Service Manual

SA-AK630GC / SA-AK630GN

Top Cabinet change (Additional Information)
Please file and use this supplement manual together with the service manual for Model No. [SA-AK630GC/GN-S, Order No. MD0501043C3].

2.1. Cabinet Parts Location (Additional Information)

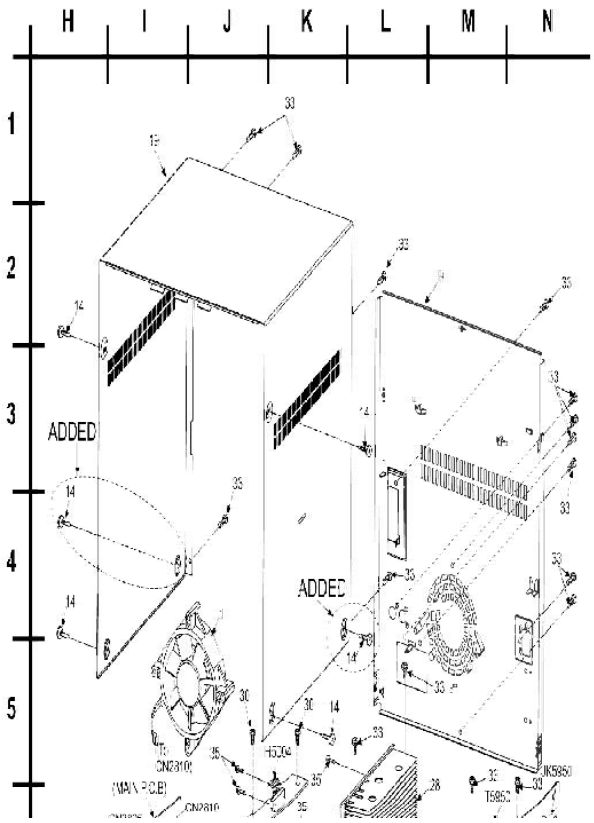
During the replacement of the top cabinet for the mentioned models, the below rules of compatibility (Table 1) must be followed & parts must be replaced correctly. This is mainly due to top cabinet specification change (additional of one screw hole) for improvements.

With reference to page 100 (section 22.3.1) of the original service manual for SA-AK630GC/GN-S. The cabinet part location below is for the new implementation.

- When replacing the new top cabinet, ensure that the NEW bottom

chassis must also be changed together at the same time (Refer to Table 1).

Ref. No.	Part No.	Part Name & Description	Remarks
		CABINET AND CHASSIS	
19	RKMX0105-S1	TOP CABINET	[M]
